Panel Decision and Report

SRP COBC073021
Boulder County, CO

November 18, 2022

Figure 3-1 – HEC-RAS Cross-Section 62978 showing Preliminary Mapped Boundaries. Note that the mapping shows a single 1% floodplain, while the HEC-RAS output would map 3 or 4 separated floodplains.

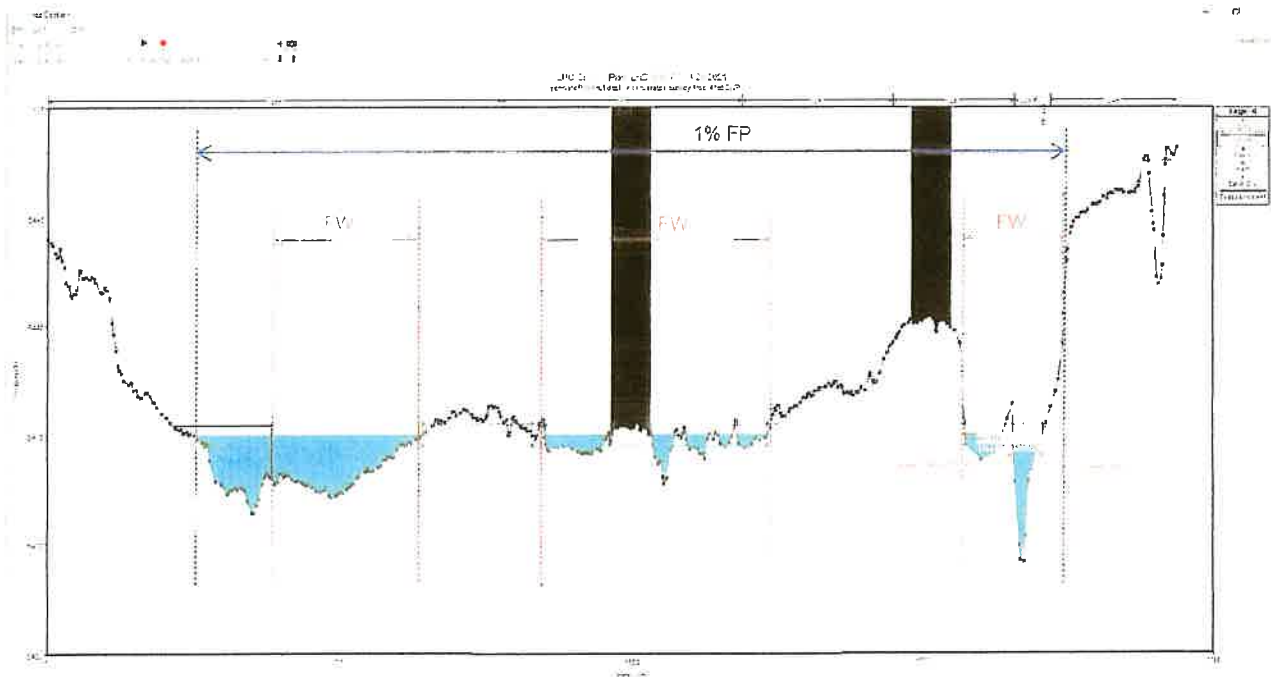
- **The FEMA data does not appear to include the topography related to extensive channel improvements in the area of concern.** Extensive improvements have been made to the Lefthand Creek main channel and overbanks, including removal of debris, channel widening, restoration of thalweg profile, restoration of overbank profiles, construction of an overflow spillway and channel on the right overbank, along with various scour and head-cutting countermeasures. All improvements were permitted by Boulder County in 2017 and 2018, with construction in 2018. Improvements were constructed based on plans developed Enginuity Engineering Solutions for the Lefthand Watershed Oversight Group and are titled Lefthand Creek Plains Reach Flood Recovery Projects, dated 12/8/16. A copy of the Enginuity plan set (stamped "Reviewed May 3, 2017 by Boulder County Building Safety") was included with the first appeal application report. Assumptions made in order to develop the HEC-RAS model do not reflect these improvements. The constructed channel improvements extend over most of the reach of the subject area of study and occurred from FEMA HEC-RAS River Station 60662 (just upstream of North 41st Street) to Station 64290 (just downstream from the Lefthand Water District diversion structure). Of special note would be the reinforced overflow spillway on the right over bank at approximately Station 64021, designed to spill channel overflows into an overflow channel in the right (south) overbank extending from Station 64021 to 63185. See figures below.

Figure 3-3 – Extent of SRH2D Modeling on Lefthand Creek.

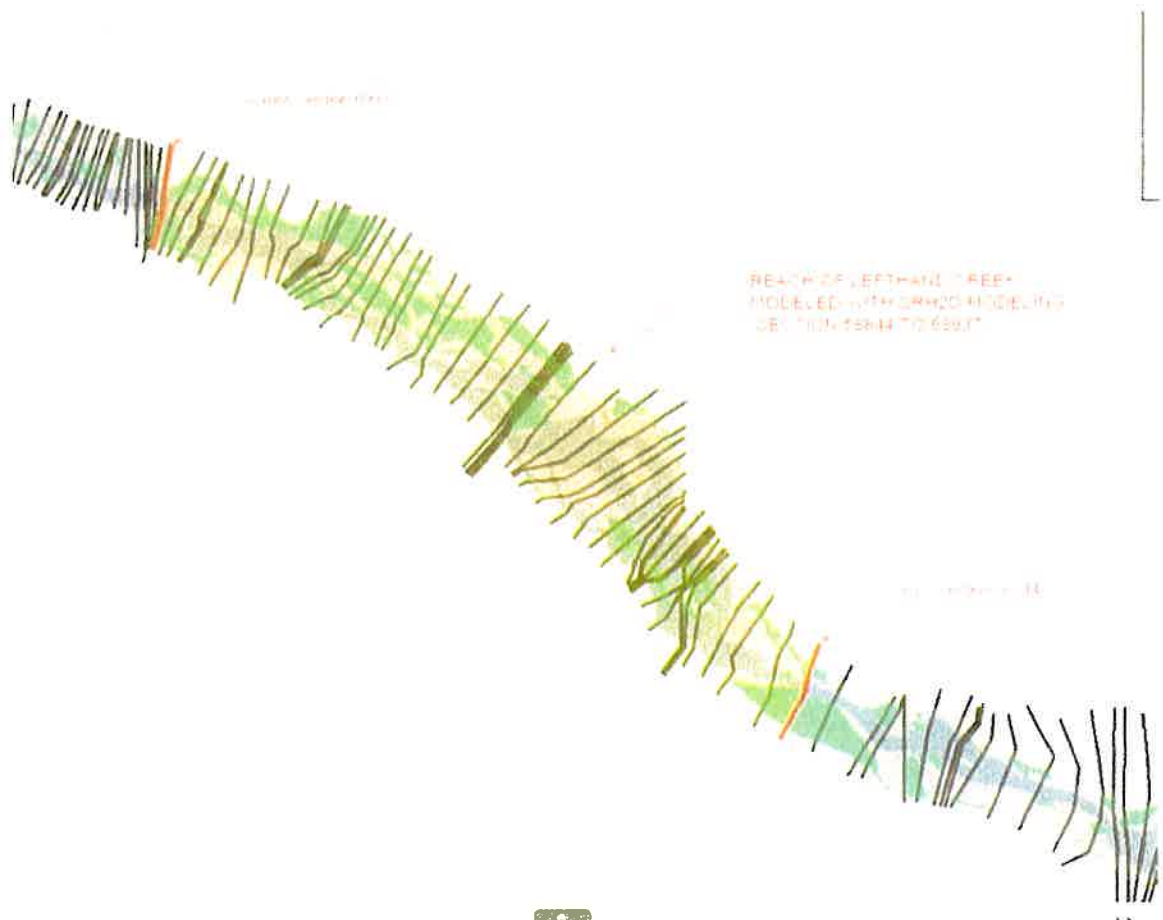
- The hydraulic HEC-RAS model results in 1% (100-year) Base Flood boundaries (shapefiles) that do not match those shown on the Preliminary floodplain mapping. It was the opinion of the appellant that this was because boundaries were determined by 2D mapping. As stated on page 20 of the AECOM Hydraulic Analysis TSDN for St. Vrain HUC-8 Watershed, Colorado, dated June 7, 2018: "An approximate model was created in SRH2D between cross sections 58844 and 69936 to inform the development of the 1D model and mapping of its results, particularly for the 1% and 0.2% profiles. Depth grids for these two profiles are included under Supplemental Data. Zone AOs were mapped based on the 2D modeling between cross sections 67446 to 65356 and 59822 to 59248". The results of the SRH2D modeling are shown on the Colorado Water Conservation Board's Colorado Hazard Mapping and Risk MAP Portal (coloradohazardmapping.com), including data and mapping of Depth Grids, Water Surface Elevation Grids, Velocity Grids, and overall Floodplain Mapping. Review of the CHAMPS maps show that the 100-year and 500-year boundaries (shapefiles) are identical to those shown on the proposed Preliminary floodplain maps, including the Zone AOs mapped between cross sections 67446 to 65356 and 59822 to 59248.

Figure 4-4: Lefthand Creek area of concern and submitted elevation comparison

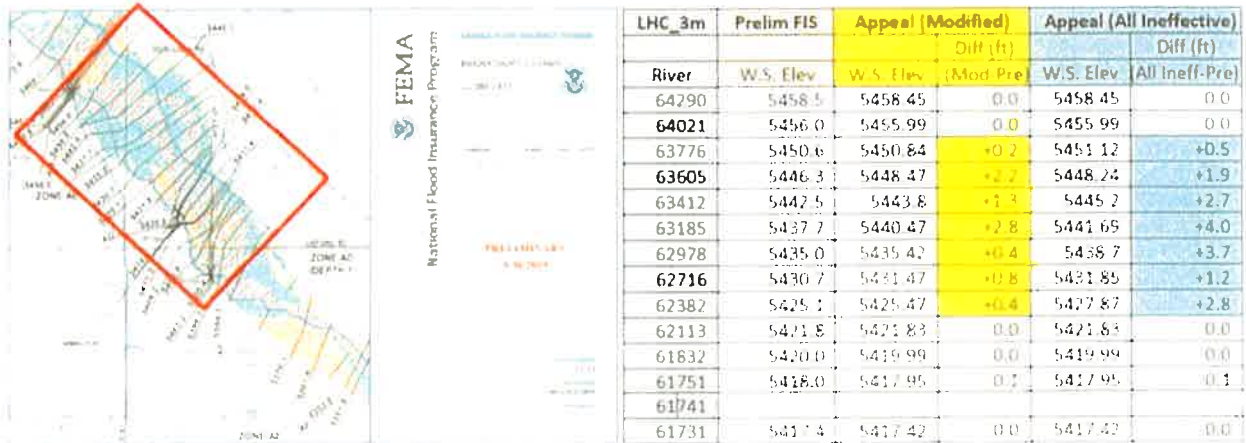
i. The methodology submitted does not support any changes to the preliminary products. As shown in Figure 1, because the submitted model’s use of ineffective areas, the Base Flood Elevation (BFE) in the channel are being raised. The increase

in the BFEs illustrates the need for the areas of concern to be within the floodway rather than be removed. The preliminary model includes the areas of concern within the floodway.

Figure 4-5: Cross Section comparison

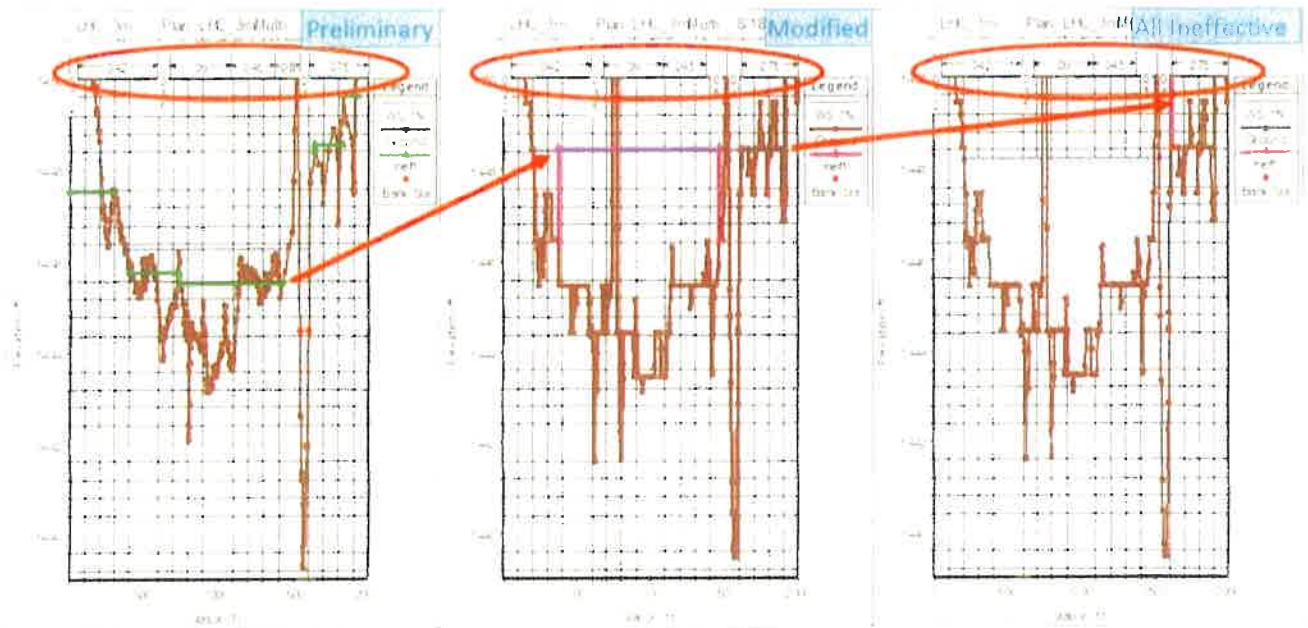
ii. The BFEs provided by the submitter are higher than the preliminary due to the applied Ineffective Flow Area as compared in Figure 2. Both models support flow in the overbank. It is unclear why additional ineffective flow is being defined when active flow is demonstrated to occur. Since that area is part of the active flow path, adding additional ineffective areas demonstrates why additional encroachments are not warranted in the overbank as they would cause a rise in the water surface elevation above the state's allowed 0.5-foot surcharge. It is recommended to revisit the ineffective flow area stations and elevations designated by submitter to determine if they are reasonable and can be justified.

Figure 7-1: Cross section orientation

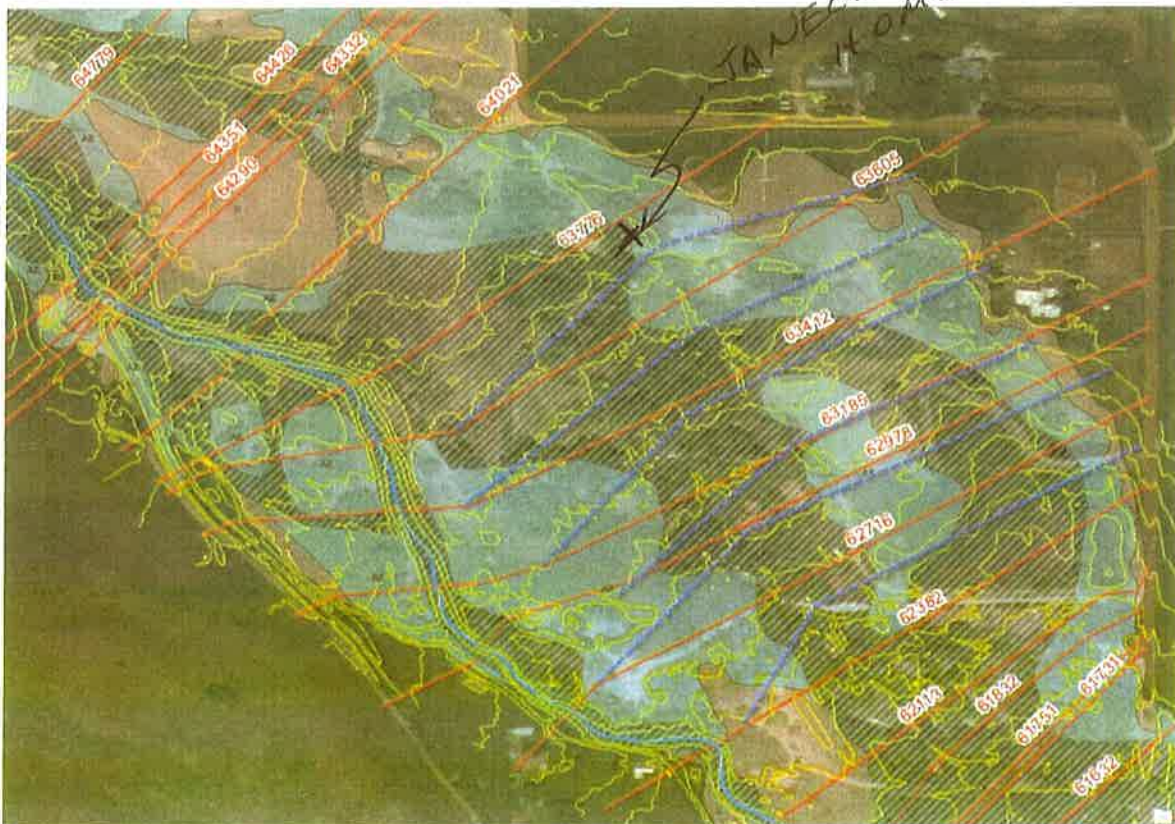
Per FEMA guidelines (FEMA, 2020) and the current HEC-RAS Hydraulic Reference Manual (HEC, 2022), "the cross sections must traverse the floodplain and be oriented perpendicular to the direction of flow," "every effort should be made to obtain cross sections that accurately represent the stream and floodplain geometry." In the vicinity of the disputed area, several cross sections are not perpendicular to the flow path (not aligned with the contour lines). Multiple breaking points could be used to assure cross sections are properly oriented across the floodplain. A couple of examples are shown (with blue dashed lines) on Figure 7-1. The Panel believes that should the cross sections be oriented more like the guidelines specify and as generally indicated below; the resultant calculated water surface elevations would be very different in the eastern areas of the subject area.

Figure 7-3: Top width for XS 65356 in the HEC-RAS model

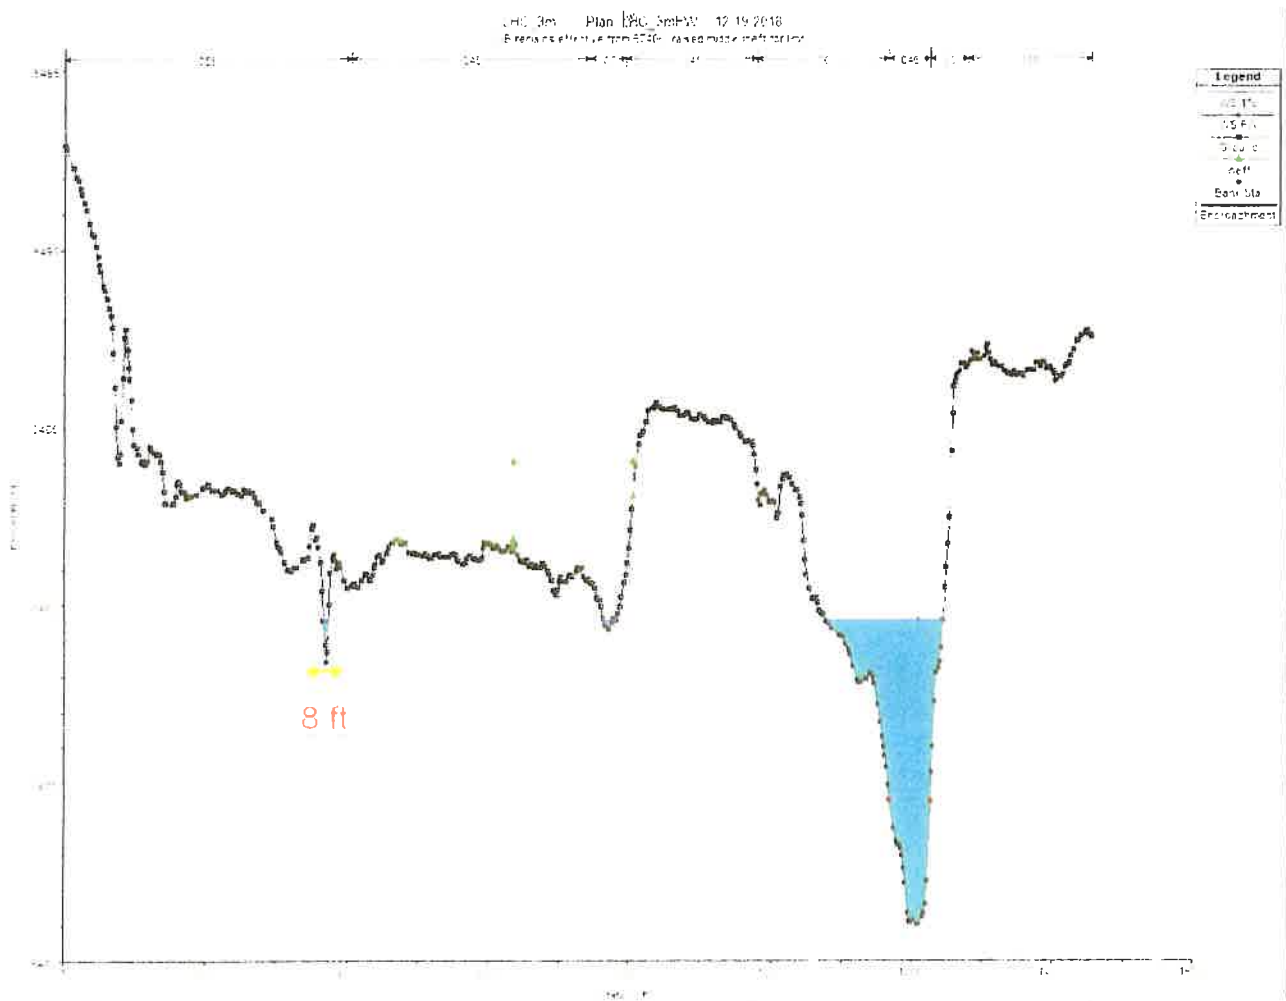
Per FEMA guidelines (FEMA, 2020) Section 3.0 Mapping of One-Dimensional Riverine Analyses, "The flood boundaries are delineated by finding the intersection of the ground surface defined by the underlying digital terrain model and the flood surface. Floodplain boundaries are delineated on the best available topographic mapping using the water-surface elevations determined at cross sections." There are discrepancies between the HEC-RAS model and the flood map in top width measurements for 100-yr floodplain extent. For example, at Cross Section 65356 the HEC-RAS model shows a top width of about 8 ft on the most left flow area. Yet, on the map at Cross Section 65356, the mapped left floodplain width measures about 85 ft.

Per FEMA guidelines (FEMA, 2019) Section 5.0 Floodway Mapping, "For one-dimensional riverine analyses, floodways are delineated at encroachment stations (limits of conveyance) at cross sections and delineated between cross sections." There are multiple discrepancies between the encroachment stations in the HEC-RAS model and floodway boundary shown on the map. As an example, the left encroachment for XS 65356 is noted (as 365.64) (Figure 7-4) while the left boundary of the floodway is about XS station 1080 ft.

Figure 7-5: Floodway delineation near the subject properties

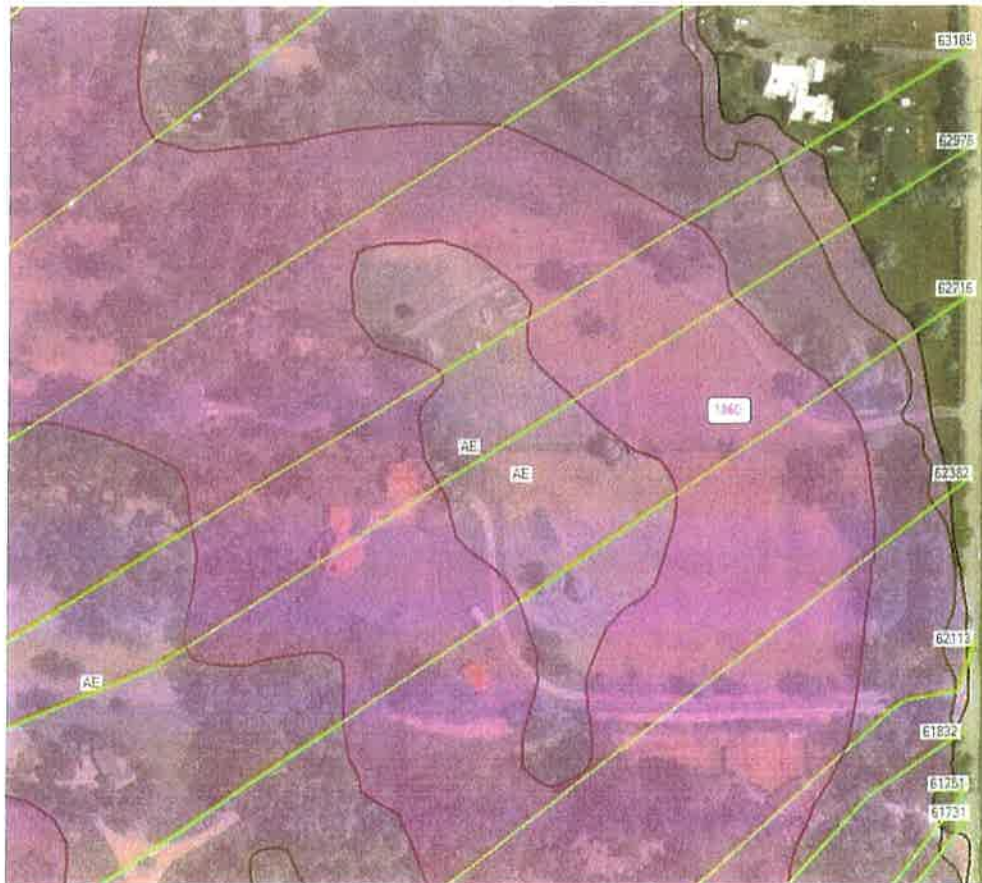
The floodway delineation process begins with hydraulic analysis by placing encroachments on the left and right overbanks of the 100-yr floodplain and gradually encroaching, following encroachment Method 4 requirements, until reaching the allowable rise in water surface elevation above the BFE (usually 1 ft). This model provides the baseline floodway encroachments, but since a floodway is a regulatory designated area, FEMA can expand it beyond the hydraulically defined boundaries to identify high hazard areas for insurance purposes. After reviewing the preliminary FIRMS, the Panel noted that floodway boundaries on the preliminary FIS maps were expanded between hydraulic cross sections XS63185-XS62716 at a few locations without any obvious underlying topographic features or obstructions. The Panel recommends review of these locations for potential re-delineations of floodway boundaries.
